TOWN OF  
**BRECKENRIDGE**

**Planning Commission Meeting Agenda**

Tuesday, December 1, 2020, 5:30 PM

1. Summit Mountain Rentals Mixed Use (CL), 1730 Airport Rd.; PL-2019-0500 **Continued** 11  
**from the November 17, 2020 Meeting**

SHEET TITLE  
**DUMPSTER BUILDING**

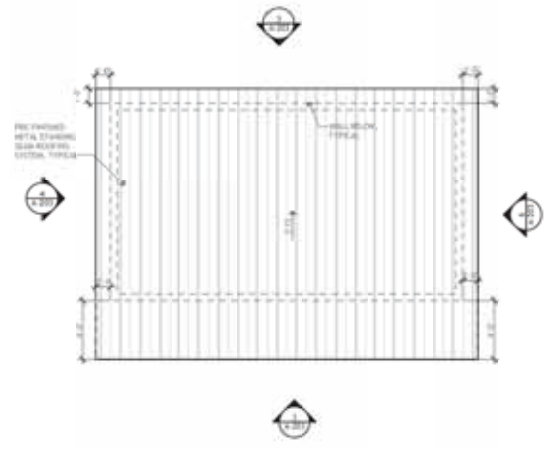
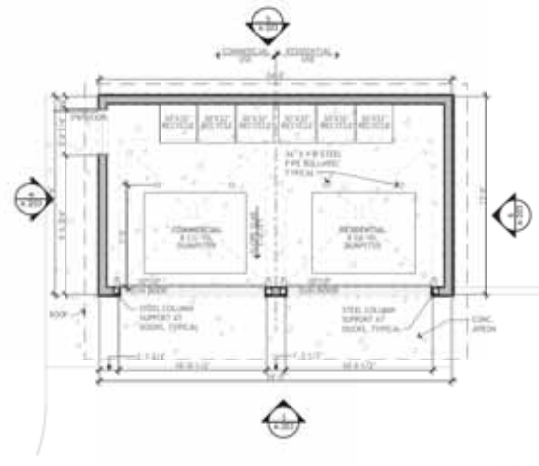
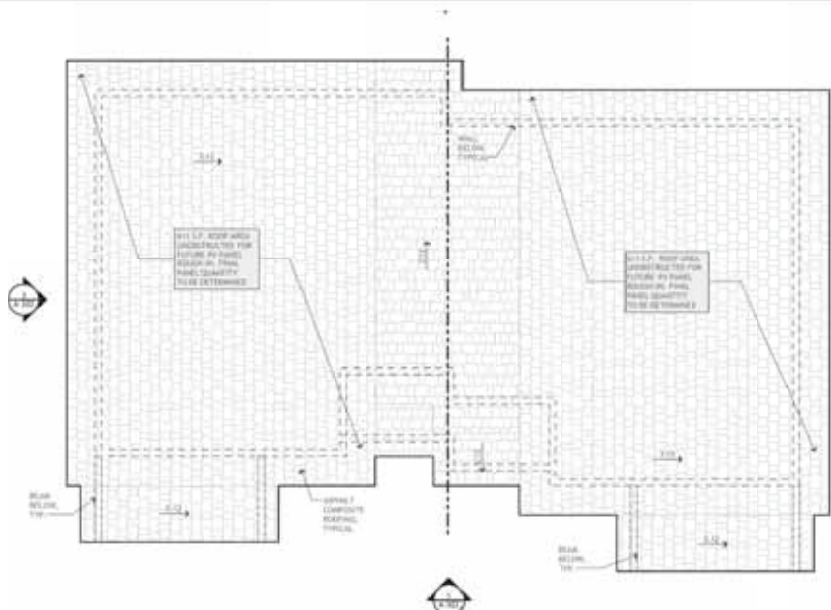
Mr. Giller: What would limit the size of a shed, outbuilding, or dumpster building? (Mr. LaChance: We count structures with walls that go all the way up to the ceiling as mass.) Your answer was limited. What would limit the size of the dumpster building with the 3 ft. of metal mesh on the uppermost portion of the wall? If they wanted to a building 3 or 4 times the size, could they? (Mr. LaChance: If the dumpster building is fully enclosed, they would just have to stay under the mass limitation. There is not necessarily a maximum size specific to dumpster buildings.) So if the building itself is at the maximum mass limit, and they are building a dumpster building with mesh tops on the walls, there is not limit? (Mr. LaChance: Yes, that is what staff is recommending. If the Commission were to find that was not the case, this project would be 285 sq. ft. or 1.6% over the recommended maximum mass.)

Mr. Beckerman: Can you explain the dumpster precedent for not being counted as mass? (Mr. LaChance: The Distillery property does not have any remaining mass available, and any additional proposed would require TDRs. The Distillery dumpster was modified after original submittal from having 4 solid sides, which would have counted as mass and required a TDR, to having one side being open aired, and was approved by staff with a Class D Minor Development and not counted as mass.)

- Ms. Delahoz: Great looking project. Excited about this.
- Ms. Leidal: I have concerns about density and mass. We are all over the place. Policy 15 requires an enclosed dumpster storage and if we are not considering this to be enclosed then it does not meet Policy 15. We should change the code. The project does not meet Policy 3 Density or Policy 4 Mass. The project should be reduced or have density transferred in. This is a beautiful project and it is not about this project. It is about the precedent that we are setting and the definition in the code for me.

- Mr. Giller: Great project. I agree with Christie and Stephen's comments pertaining to the dumpster. The project is over on mass.
- Mr. Schuman: Policy 15/A is really clear. Staff has counted past applications correctly. I don't think any change is needed, as long as we continue along the path that the staff has progressed to this point. It is actually doing exactly what we wanted. We want dumpster enclosures in all of Breckenridge. The Policy has worked as designed. I appreciate the changes. Really good looking project. Look forward to seeing it in the ground.

**Mass (4/R):** At the last Hearing, four (4) of the seven (7) Commissioners expressed concern that the proposed 324 sq. ft. (162 sq. ft. residential/162 sq. ft. commercial) open-aired dumpster enclosure should be counted as mass. Since the Hearing, staff conducted considerable research on previously permitted dumpster enclosures, finding the 16 past precedents listed below, some processed at a staff level and some through the Planning Commission public hearing process. Eight (8) of the 16 were open-aired, and all of those were not counted as mass. Five (5) of the 16 were fully enclosed and also not counted as mass. Two (2) of the 16 were associated with Class A workforce housing developments, were fully enclosed and were counted as mass.

The Town Attorney has reviewed these past precedents and has provided the attached memorandum to the Planning Commission supporting staff's analysis that the proposed open aired dumpster enclosure should not be counted as mass. Not counting the dumpster enclosure as mass, staff finds the proposed 14,531 sq. ft. of mixed use complies with the mass recommendation of 14,582 sq. ft. (1:4 FAR), with 51 sq. ft. remaining. If the Commission disagrees and finds the open aired dumpster enclosure to be mass, the project would exceed the recommended mass by 285 sq. ft. (1.6%)

4/R	Mass	5x (-2>-20)	0	Allowed: 14,582 sq. ft. Proposed: 14,531 sq. ft. Open-aired dumpster not counted as density based on past precedent.
5/A	<b>Architectural Compatibility / Historic Priority Policies</b>	Complies		
5/R	Architectural Compatibility - Aesthetics	3x(-2/+2)	0	Architecture meets the "contemporary" recommendation of the LUGs. Building features are highly functional, including such features as south facing glazing for passive solar gain, and are without excessive detail or monument. Each elevation of each building does not exceed 25% non-natural materials, and features natural materials, including wood siding, wood beams and trim, and stone veneer.
5/R	Architectural Compatibility / Conservation District	5x(-5/0)		
5/R	Architectural Compatibility H.D. / Above Ground Density 12 UPA	(-3>-18)		
5/R	Architectural Compatibility H.D. / Above Ground Density 10 UPA	(-3>-6)		
6/A	<b>Building Height</b>	Complies
